<b>Project</b>	IEEE 802.16 Broadband Wireless Access Working Group < <a href="http://ieee802.org/16">http://ieee802.org/16</a> >	
<b>Title</b>	<b>Rate=5/6 LDPC Coding for OFDMA PHY</b>	
<b>Date Submitted</b>	2005-03-09	
<b>Source(s)</b>	<b>Robert Xu, David Yuan, Li Zeng, Liu Jun Hu ZTE Inc.</b>  <b>3/F, Bldg.711, Pengji Industrial Park, Liantang, Shenzhen, 518004</b>	<b>Voice: +86 755 26773000 6574 Fax: +86 755 26773000 6616 mailto: <a href="mailto:xu.jun2@zte.com.cn">xu.jun2@zte.com.cn</a>  <a href="mailto:yuan.liuqing@zte.com.cn">yuan.liuqing@zte.com.cn</a> <a href="mailto:zeng.li@zte.com.cn">zeng.li@zte.com.cn</a>  <a href="mailto:hu.liujun@zte.com.cn">hu.liujun@zte.com.cn</a></b>
<b>Re:</b>	<b>Response to Sponsor Ballot on IEEE802.16e/D6 document</b>	
<b>Abstract</b>	<b>In this contribution, <u>Rate</u>=5/6 LDPC codes are provided to complete LDPC in IEEE802.16e.</b>	
<b>Purpose</b>	<b>To incorporate the text changes proposed in this contribution into the 802.16e/D6 draft.</b>

## **Rate=5/6 LDPC Coding for OFDMA PHY**

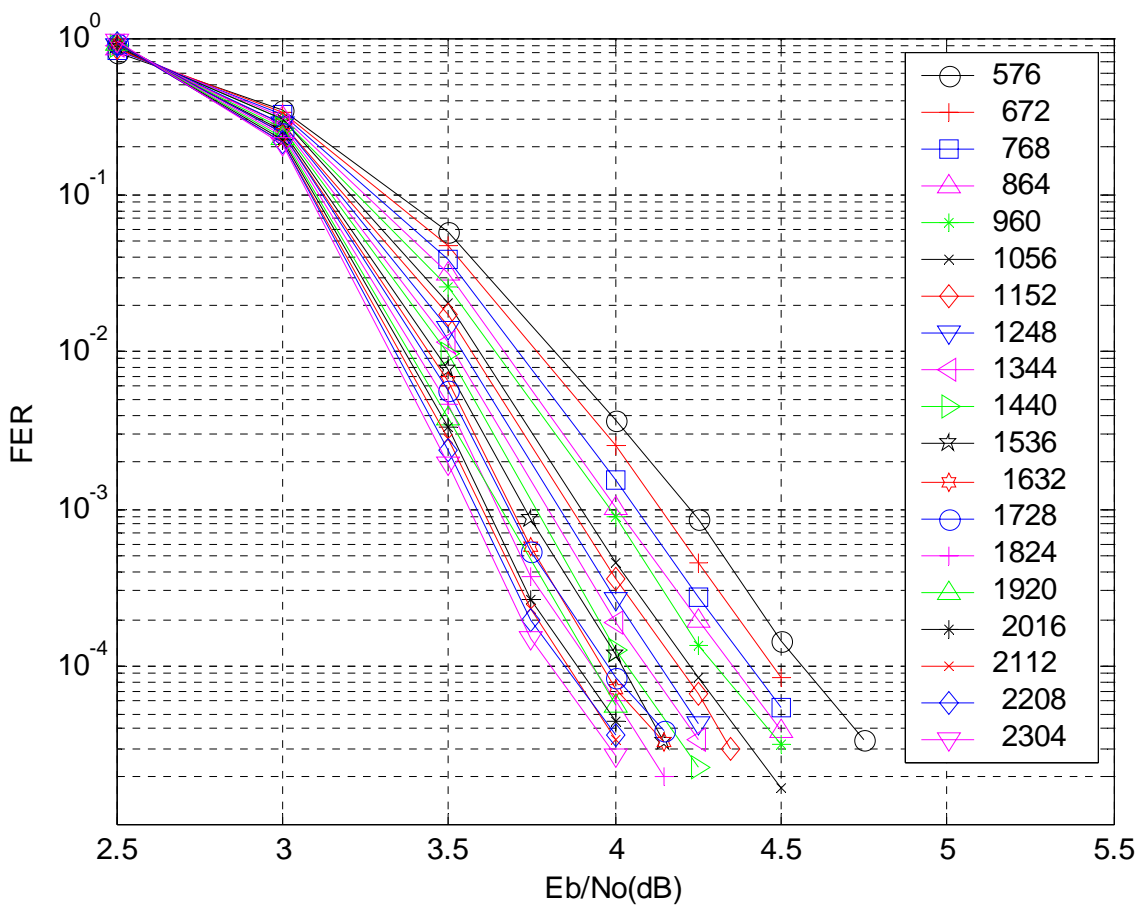
Simulation results for ZTE high girth codes of the rate 5/6 code families are shown in Figure 1. For the rate, code sizes considered are all 576-2304. The simulation conditions are: AWGN channel, BPSK modulation, max iterations times 50, using generic floating-point belief propagation. From the simulation results we can find that our codes overcome the “error floor” phenomenon, and the BER curve of them will descend more steeply. When SNR is high, our high girth method obviously obtained an improved performance. The expansion factor  $z$  ranges from 24 to 96, as shown in Figures 1. The block size and the expansion factor are related by  $n = 24 * z$ .
